CITY OF ALBUQUERQUE

RE: **Lot 17, Blk 1 Cliffs Unit 22 SAD 228**
8015 Agua Fria Ct. NW
Grading and Drainage Plan
Engineers Stamp Date 10/29/2020 (D10D003N117)
Pad Certification Date: 3/11/2021

Ernest Armijo, P.E.
Principal Engineer, Planning Dept.
Development Review Services

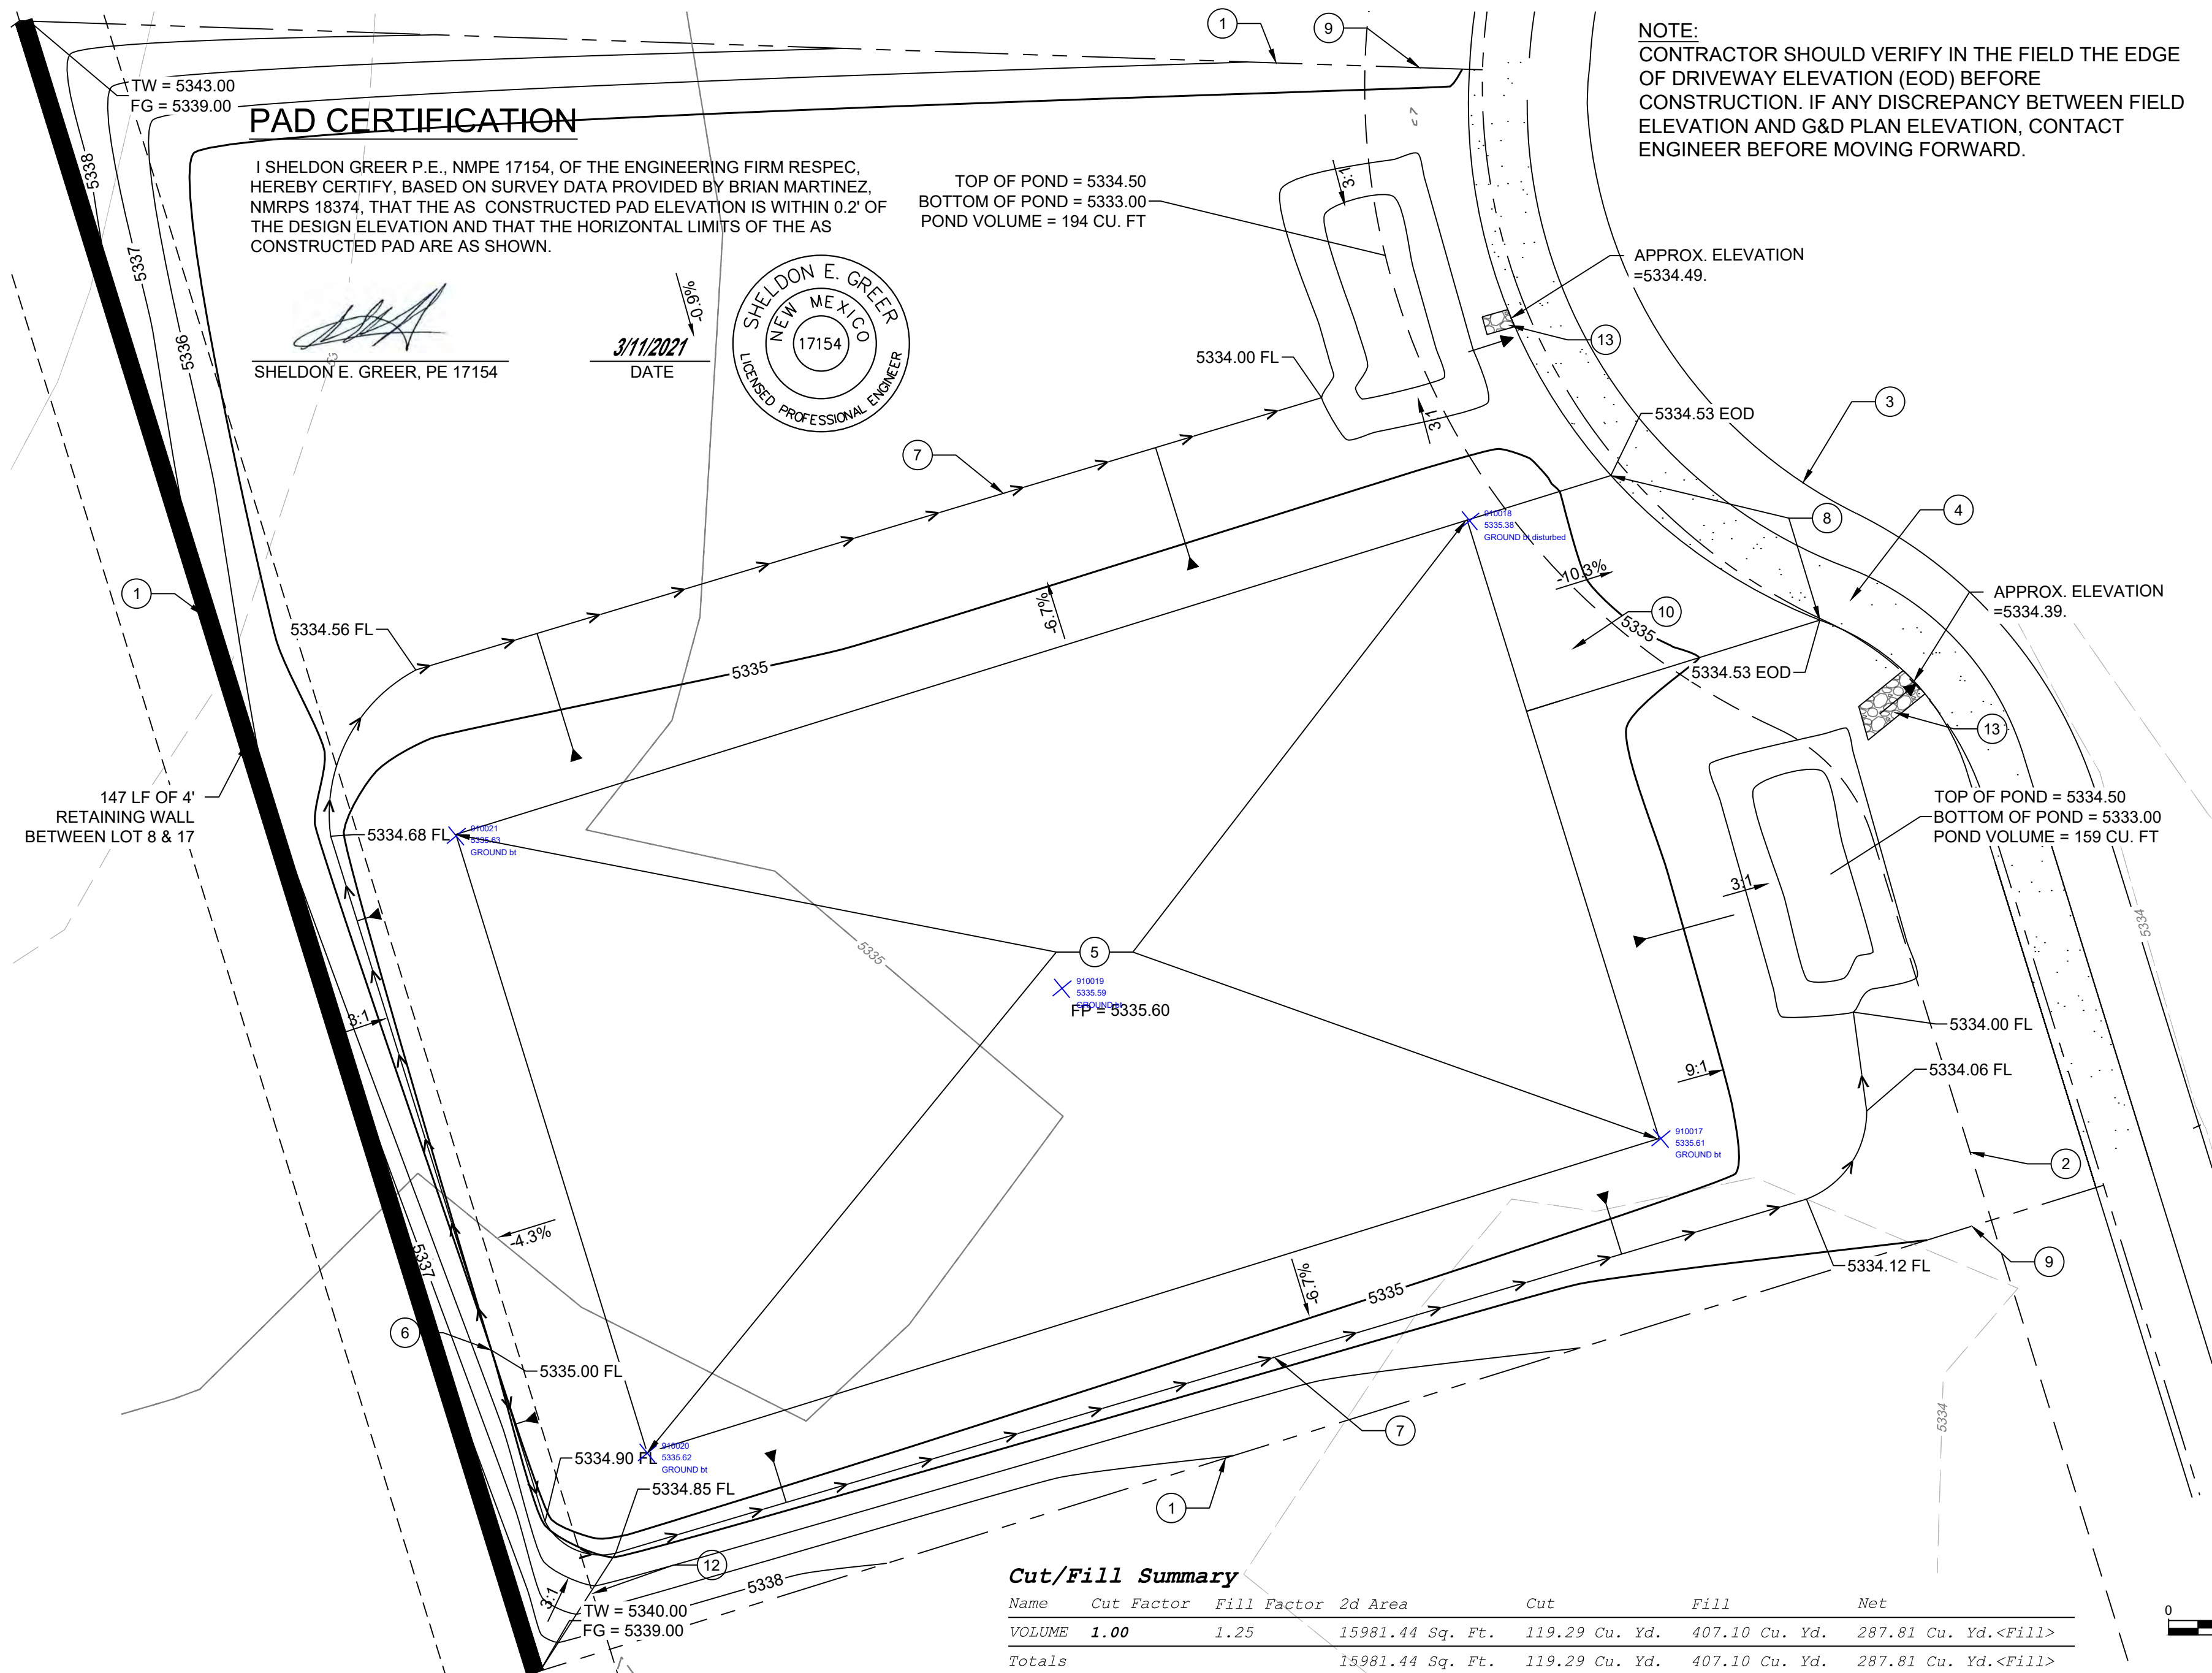
Based upon the information provided in your submittal received 4/19/2021, this plan is approved for Building Permit.

Prior to Building permit approval a Pad Certification will be required, provided by the Engineer or a registered Land Surveyor.

Reiterate to the Owner/Contractor that a separate permit for a garden/retaining wall must be obtained with the approved G&D plan and Pad Certification. **Also, if a swimming pool is to be placed the grading and drainage plan will change and will need to be resubmitted.**

Prior to Certificate of Occupancy release, Engineer Certification per the DPM checklist will be required.
